**FAIRCLOTH - GARAGE  
5244 COOL SPRINGS RD  
BROADWAY, NORTH CAROLINA**

**FOUNDATION PLAN**

**ENGINEERED SUBMITTAL**  
 This submittal has been reviewed for specified design criteria & compatibility with building structure. The design of these components is the responsibility of those providing the components.  
 HMHendrick Enterprises, Inc.  
 By: **HMH** Date: **09/30/25**

**Johnny Faircloth**  
**Garage**  
**ROOF PLACEMENT PLAN**

WALL SECTION  
SCALE: 1/2"=1'

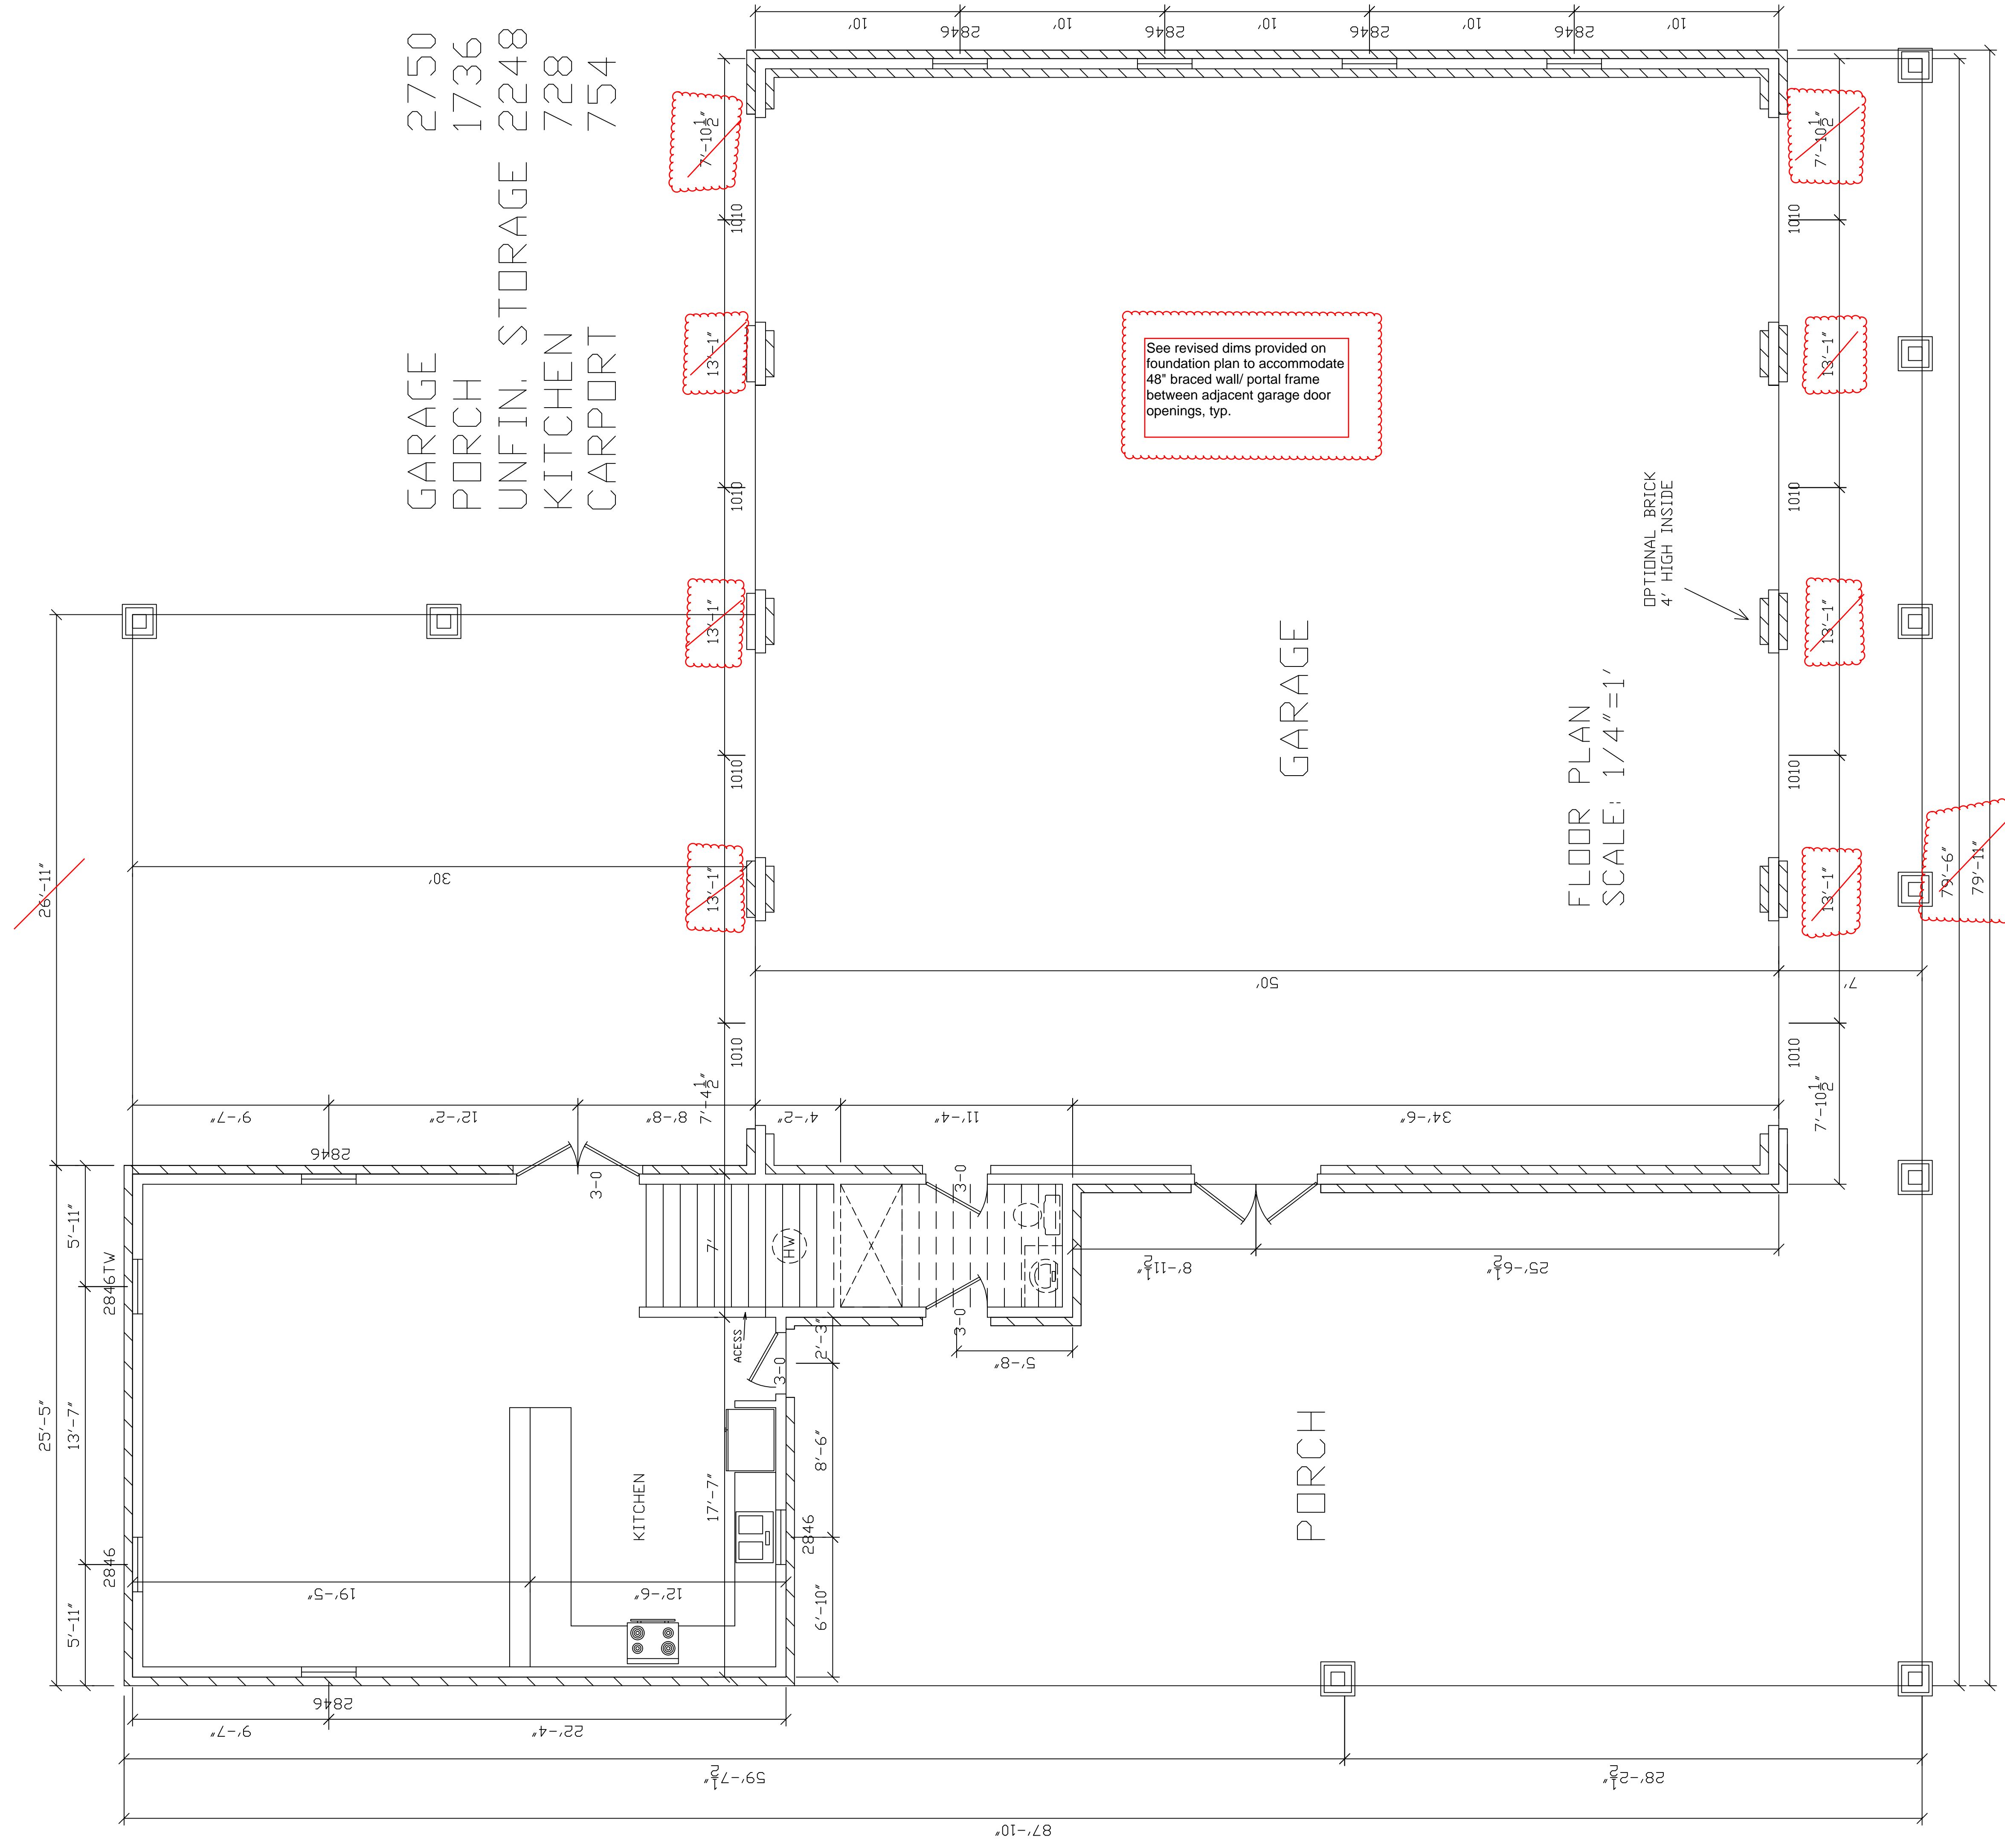
FIBERGLASS SHINGLES  
OVER 15 # FELT  
TRUSS DESIGN BY SUPPLIER  
~~7/16"~~ 1/2" OSB SHEATHING  
R-30 INSULATION  
LVL BEAM DESIGN  
BY SUPPLIER  
~~7/16"~~ 1/2" OSB SHEATHING  
HOUSE WRAP  
R-15 INSULATION

See foundation plan.

FLOOR PLAN  
 SCALE: 1/4"=1'

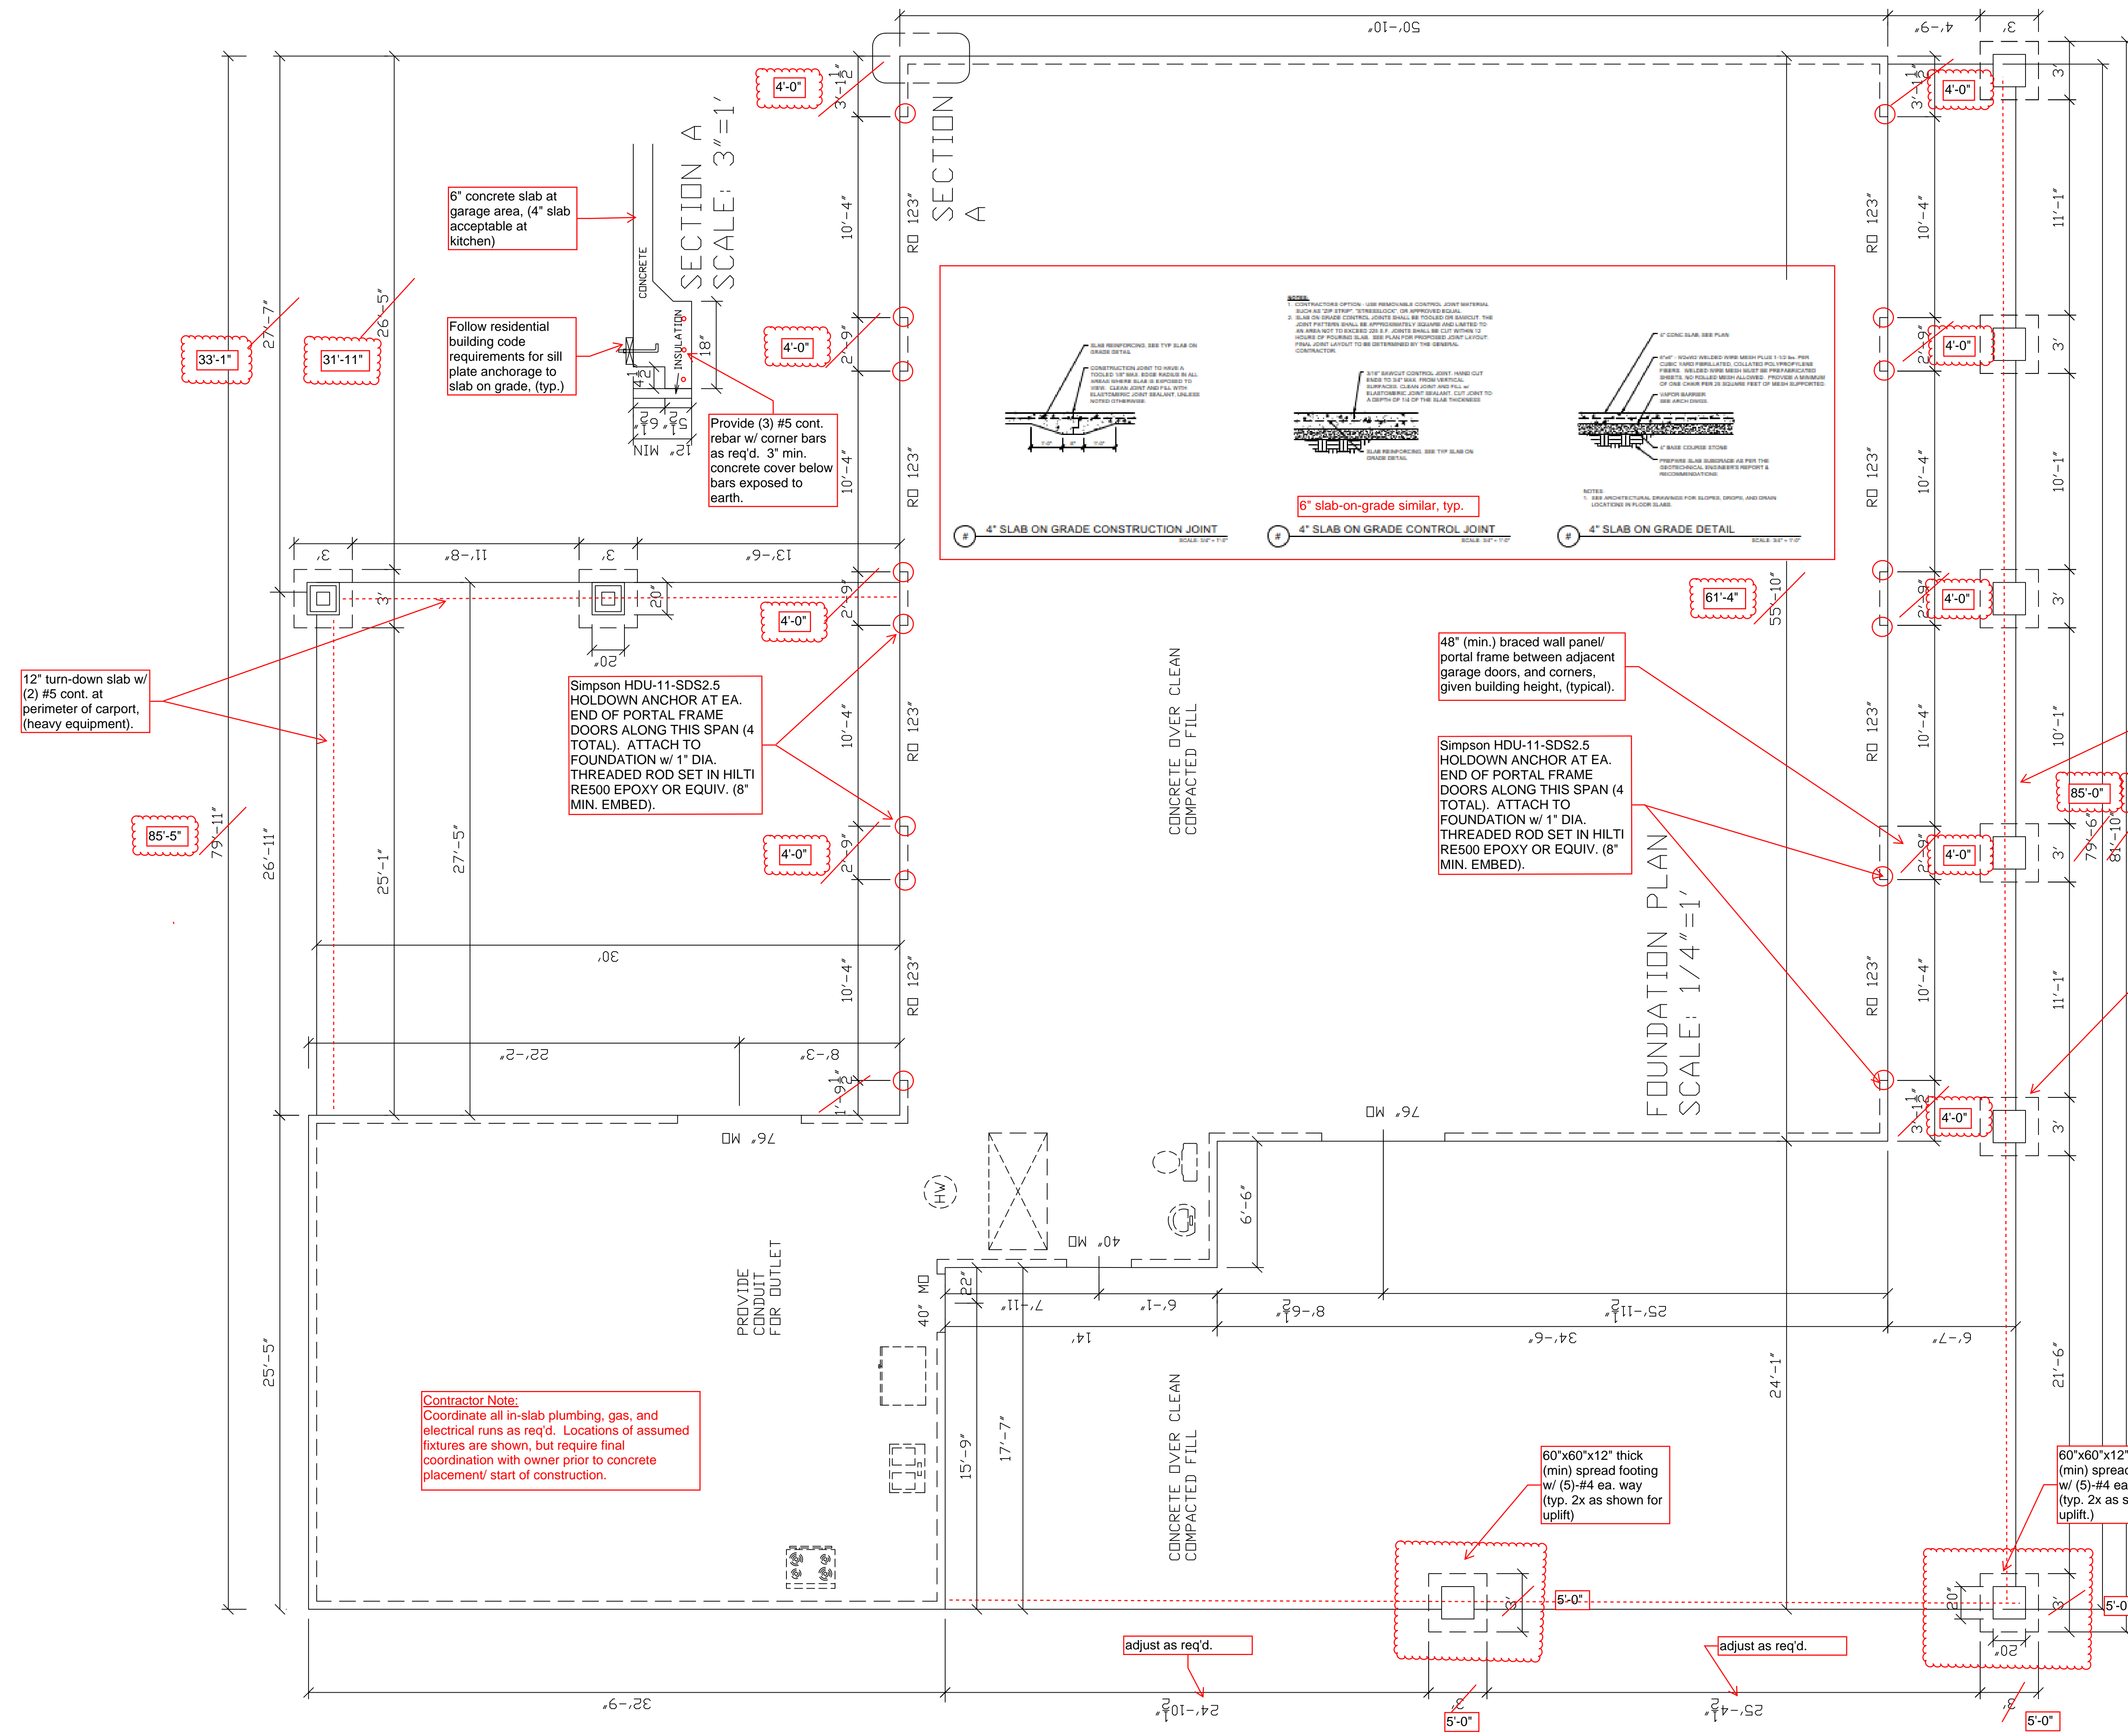
See revised dims provided on  
 foundation plan to accommodate  
 48" braced wall/ portal frame  
 between adjacent garage door  
 openings, typ.
